Work Order ID 79608***79608***

Item Name: Mounting Lug

DRAWING NO. D2731	TITLE MOUNTING LUG	REV. C	DART AEROSPACE USA, INC ENGINEERING ORDER		D.E.O. NO. D2731-C-1	SHEET NO. SHEET 1 OF 1	SCALE NTS
DRAWN qp	CHECKED sc	MFG. APPR. M	APPROVED MAD		DE APPR. H		
DATE 11.05.02	DATE 11.05.09	DATE 11.05.09	DATE 11.05.09		DATE 11.05.09

ADD D2731-xRG OPTION

D2731-1RG MOUNTING LUG (SHOWN)
D2731-3RG/-5RG/-7RG MOUNTING LUGS (SIMILAR)

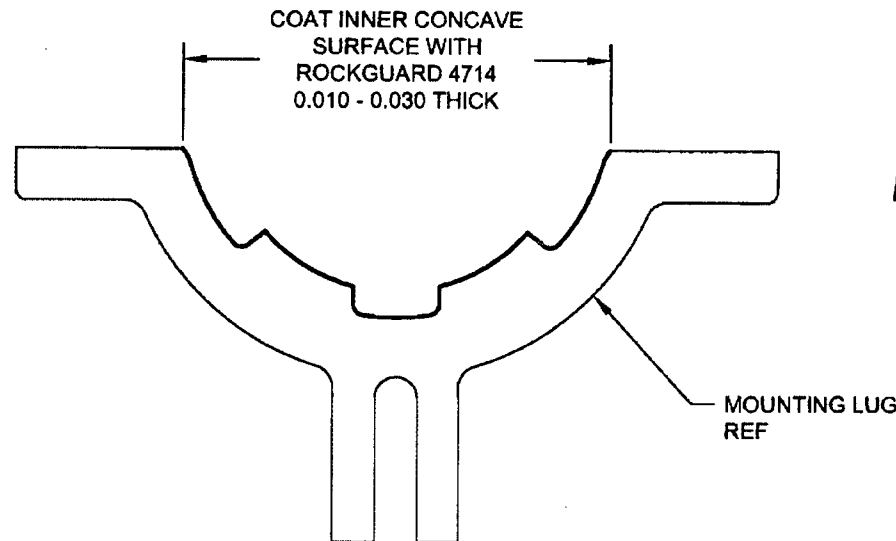
D2731-xRG MOUNTING LUGS ARE IDENTICAL TO D2731-x MOUNTING LUGS, HOWEVER AFTER FINISH, COAT INNER CONCAVE SURFACE WITH "PLUS ONE ROCKGUARD 4714" AS SHOWN BELOW.
